ENGINE SYSTEMS, INC.

Subject: 10CFR21 Reporting of Defects and Non-Compliance -
Engine Systems, Inc. Report No. 10CFR21-0123, Rev. 0

EMD Fuel and Soakback Pumps – Potentially Undertorqued Cover Bolts

Report No. 10CFR21-0123

Figure 1: Exploded View of Pump P/N 8410219

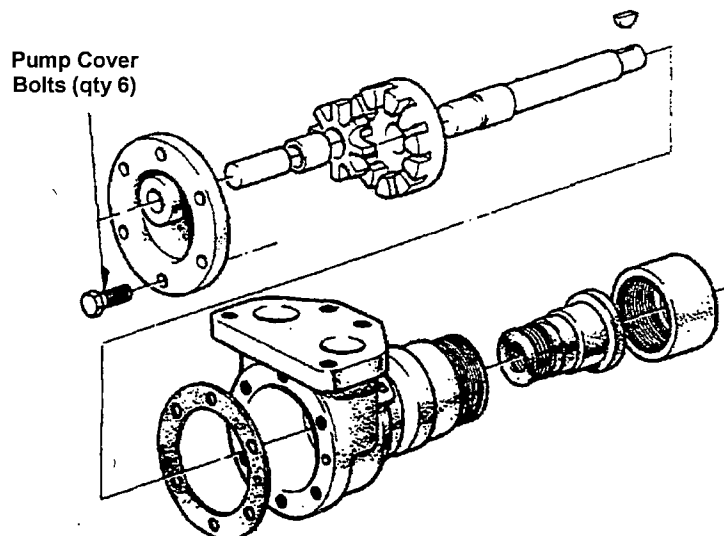
ESI was notified by a nuclear customer of two instances where a bolt was found loose or backed out of the cover of an EMD engine driven fuel pump P/N 8410219. Following notification, ESI inspected remaining pumps in inventory and found instances where one or more the pump cover bolts were loose or lightly torqued. See Figure 1 below for a visual depiction of the pump and bolts.

ESI recommends inspecting the bolts of all pumps for proper bolt tightness. Use a torque wrench and ensure all bolts are tightened to 108 to 120 in-lbs (12 to 13 Nm).
